SUBJECT: SERVICE ADVICE LETTER FOR IMMEDIATE ACTION AND  
CAMPAIGN TREATMENT

MODEL: ALL HUMBER SUPER SNIPE SERIES  
I, II & III UP TO B 8102659

### AFFECTED UNIT STEERING COLUMN

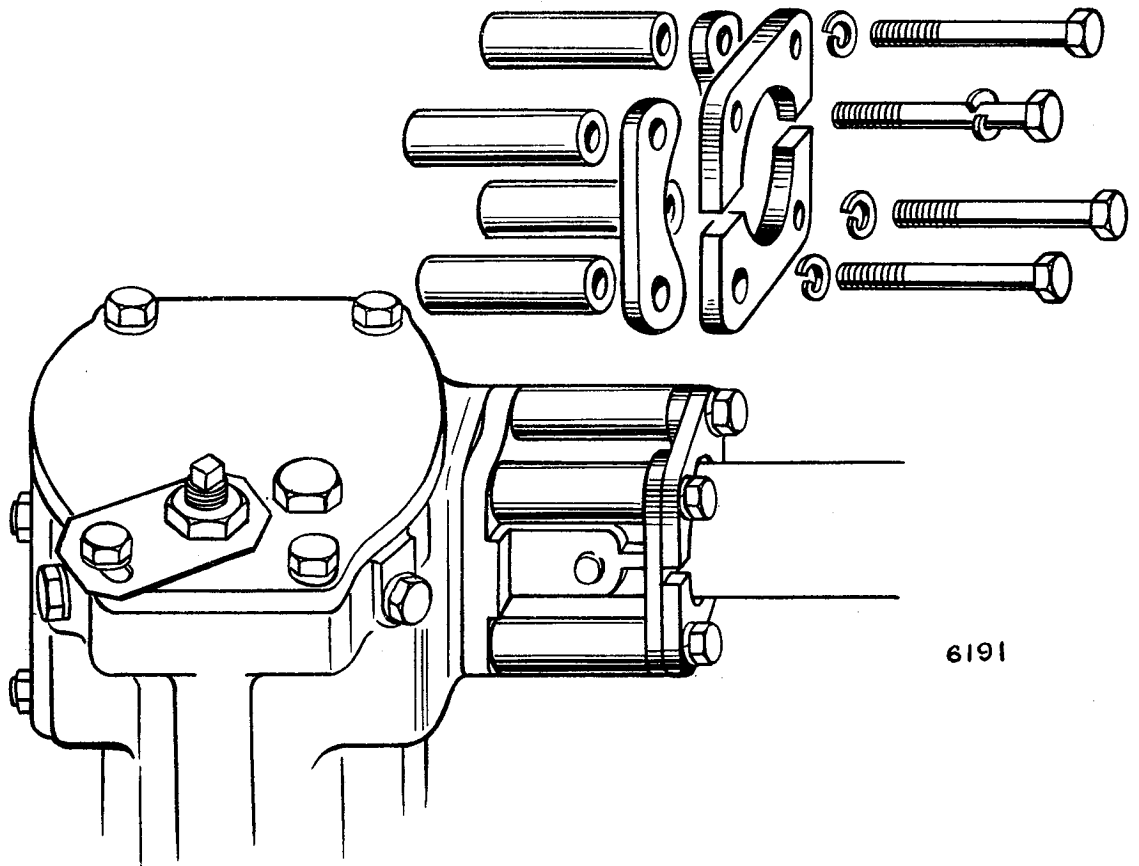
4. Clean off the flange and examine for any sign of cracking - if cracks are evident remove steering unit complete and fit new modified outer column to the following part number:-

5. Discard the bolts removed and fit the parts described below, as shown in the illustration:-

Steering outer column to suit felt top bush - Part No. 5039327

<u>Description</u>	<u>Quantity.</u>	
Stiffener	2	)
Stiffener Plate	2	)
Distance Tube	4	) Kit No. 5220594
Bolt (2 3/8" long)	4	)
Spring Washer	4	)

Fig. 1.

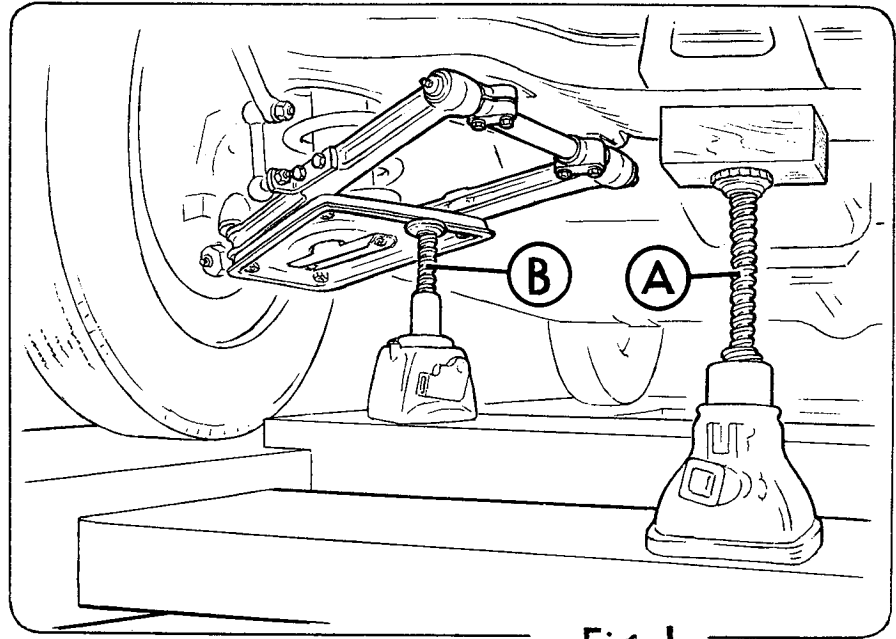
1. Place the car on ramp and apply the handbrake.
2. The weight must be taken off the front end of the car by using a jack situated under the front cross member as illustrated in Fig. 1 (a), but ensuring the tyres remain in contact with the ramp.
3. Place another jack under the coil-spring abutment plate, carefully positioned and off-set slightly to rear as shown in Fig. 1 (b). Jack up the suspension so that the linkage will bear up against the cross member when the inner fulcrum pin bracket bolts are loosened.
4. Remove and discard the bolt in the non-slotted side of the front bracket, bending the lockplate clear. Fit new bolt and spring washer but do not tighten until action as described in the following paragraph has been taken.

Fig. 2.

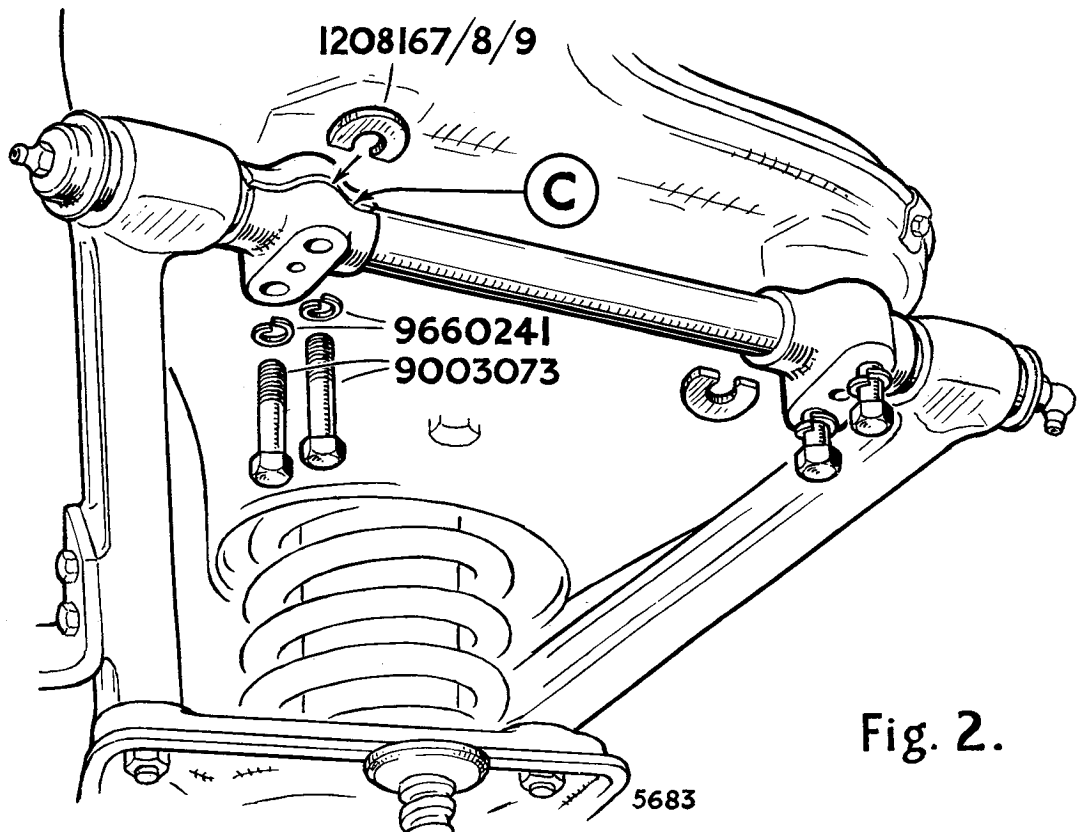
Remove and discard bolt and lockplate in the slotted side of the front bracket. Select a new spacer washer from the various thicknesses listed below so that there is a clearance of .005"/.010" when it is in position in the slot (see Fig. 2 (c) ). If this clearance cannot be achieved with the spacer washers provided the washer must be faced down to suit.

Fit new bolt and spring washer and tighten both bolts to a torque loading of 42 lbs. ft.
